TECHNICAL MEMORANDUM

Subject: Review of Sound Management Plan

Reference: HMMH Project Number 310430

Figure 2. Planned Flight Tracks to Proposed Heliport

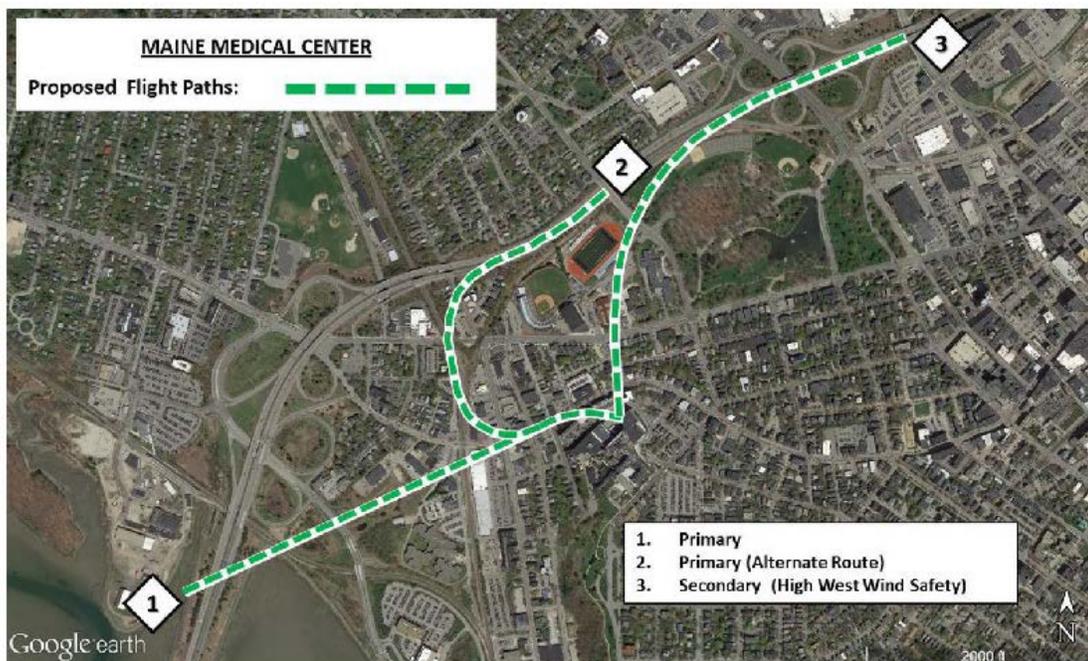
The SMP states they will measure four (4) sorties, each consisting of an approach, a 30-second hover and a departure, but is vague about the path/location stating the existing *and* proposed helipads. It is recommended the SMP specify the sorties approach the East Tower, perform a 30-second hover at the approximate elevation of the proposed helipad (simulating a landing to the pad and a takeoff from the pad), and depart the East Tower, on the proposed flight tracks shown in Figure 2 of the 2017 noise study (Russell Acoustics 2017)², reproduced here as Figure 2. Also, the SMP should specify whether the sorties will utilize approach paths 1 or 2 (or a mixture of both) from Figure 2. A mixture, e.g., 2 on each, is preferred. A total of four (4) sorties is probably sufficient, if the flight paths (including altitude and pilot technique) can be documented/verified as being similar to each other, e.g., both flight paths on Track #1, and the approach/departure portions documented/verified as being typical of air ambulance operations.
